AURIX™ TC35x errata sheet

Marking/Step: (E)ES-AB, AB

10470AERRA

Figure 1 Message buffer transfer from Message RAM to OBF

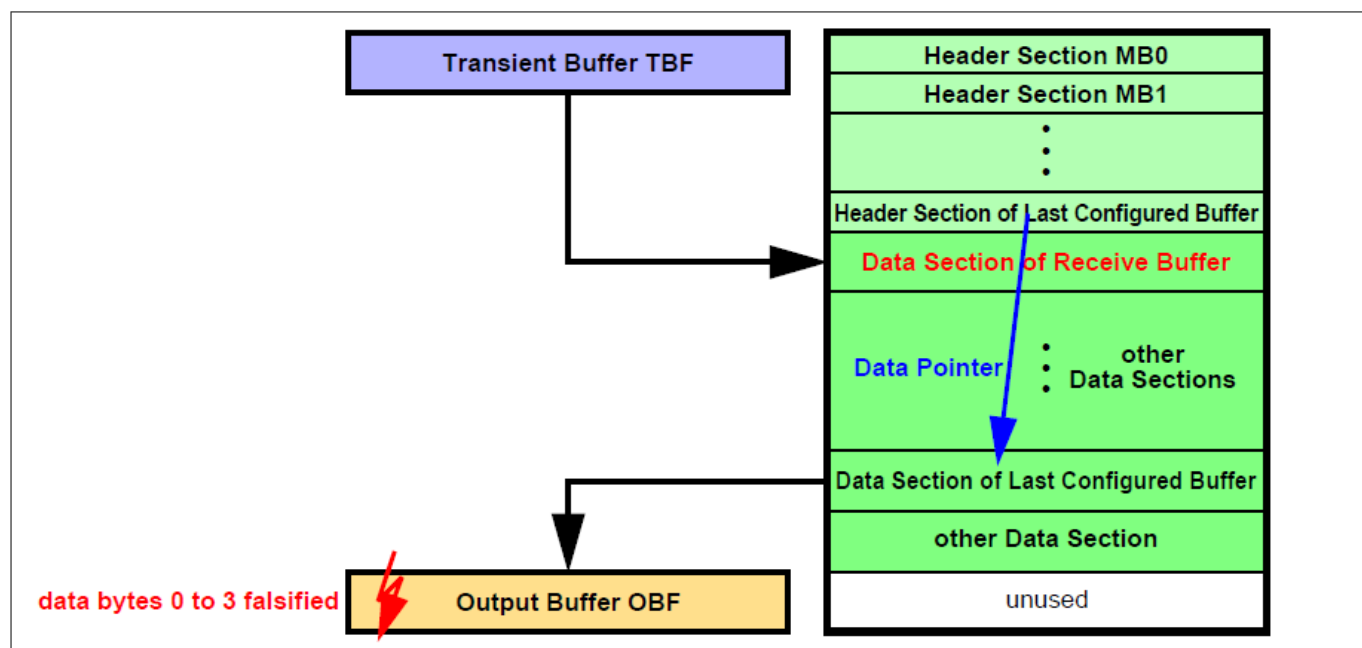
When the message buffer has its payload configured to maximum length (PLC = 127), the OBF word on address 00h (payload data bytes 0 to 3) is overwritten with unexpected data at the end of the transfer.

a) When a message is transferred from the Last Configured Buffer in the Message RAM to the OBF and PLC = 127 it may happen, that at the end of the transfer the OBF word on address 00h (payload data bytes 0 to 3) is overwritten with unexpected data (see [Figure 1](#))

Ensure that the Data Section directly following the Header Partition is assigned to a transmit buffer.

Figure 2 Message buffer transfer from IBF to Message RAM

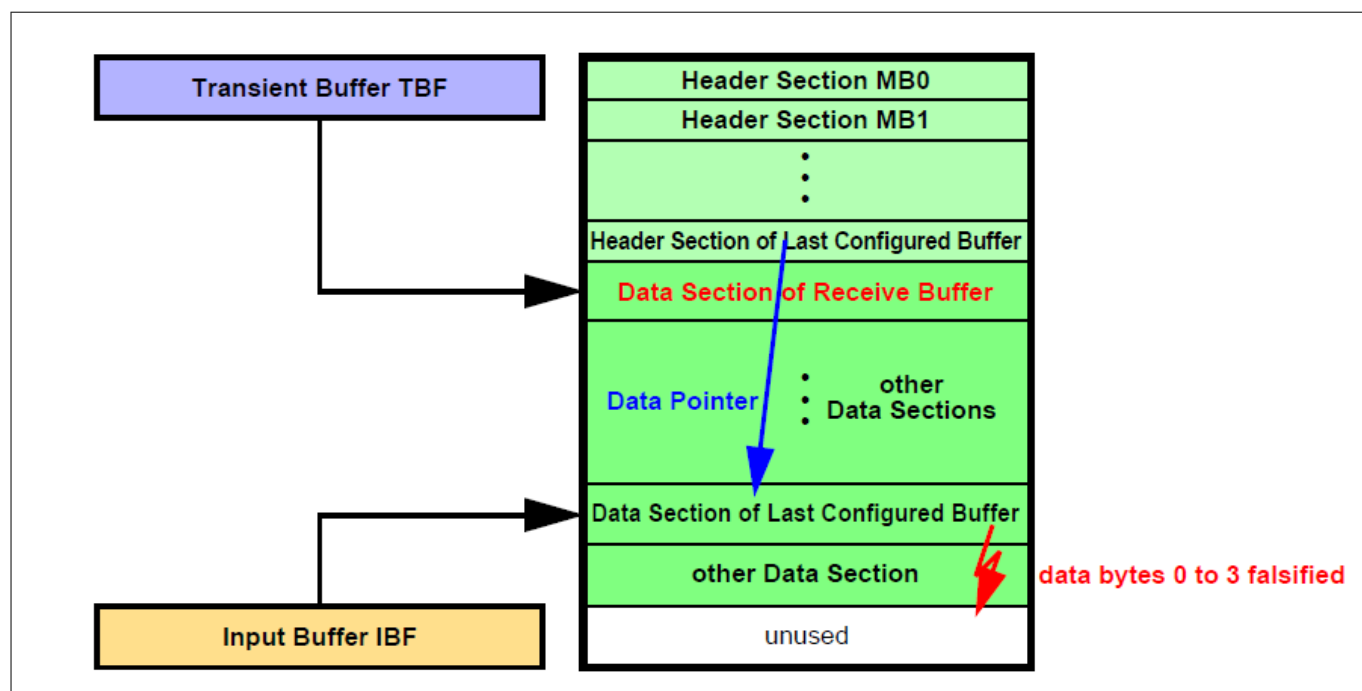
After the Data Section of the selected message buffer in the Message RAM has been written, one additional write access overwrites the following word in the Message RAM which might be the first word of the next Data Section.

b) When a message is transferred from IBF to the Last Configured Buffer in the Message RAM, it may happen, that at the end of the transfer of the Data Section one additional write access overwrites the following word, which may be the first word of another message's Data Section in the Message RAM (see [Figure 2](#))

Figure 3 Message RAM configurations

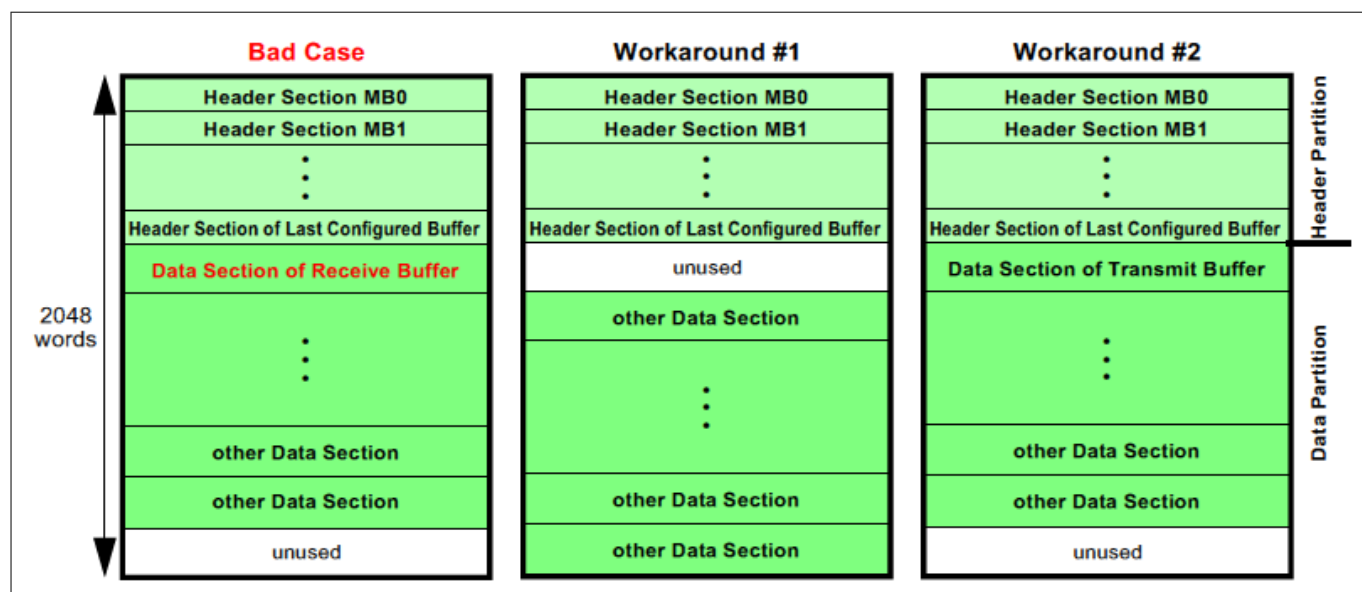
The erratum is limited to the case when (see [Figure 3](#) “Bad Case”):

Figure 5 CAN Frame with DLC > 4

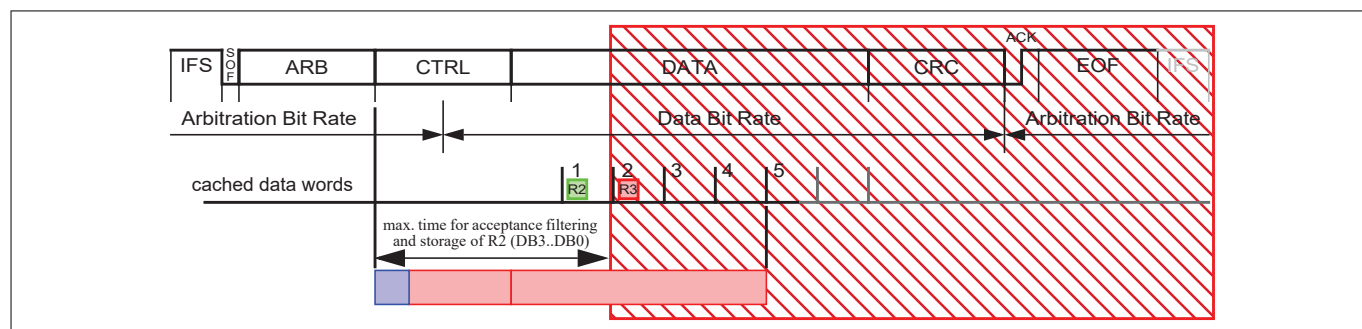
The figure that follows shows how the available time for acceptance filtering and storage is reduced.

Due to condition 3) the issue only occurs sporadically. Use an end-to-end (E2E) protection (for example, checksum or CRC covering the data field) and add it to all messages in the CAN system, to detect data corruption in received frames.

Figure 6 Positive overload on P-pad of a LVDS RX pin pair (both used as inputs)

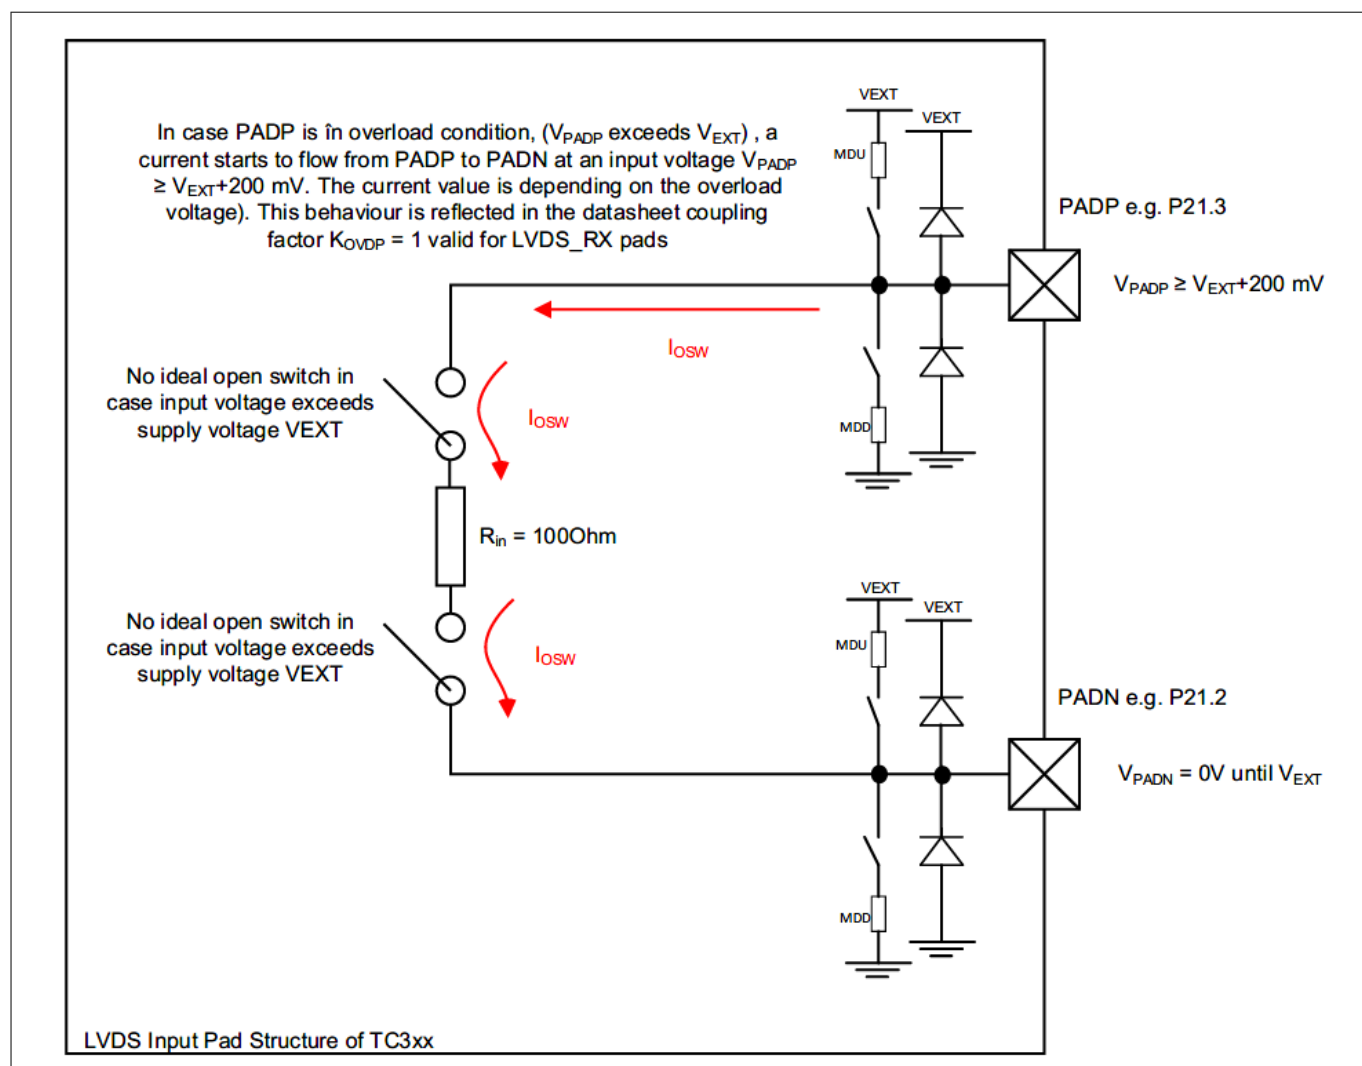
The overload current I_{OSW} through the non-ideal open switch significantly increases when $V_{PADP} \geq V_{EXT} + 200 \text{ mV}$.

Note: In general, the effect will also occur if the N-pad is used as output, or for a negative overload condition on either the P-pad or the N-pad.
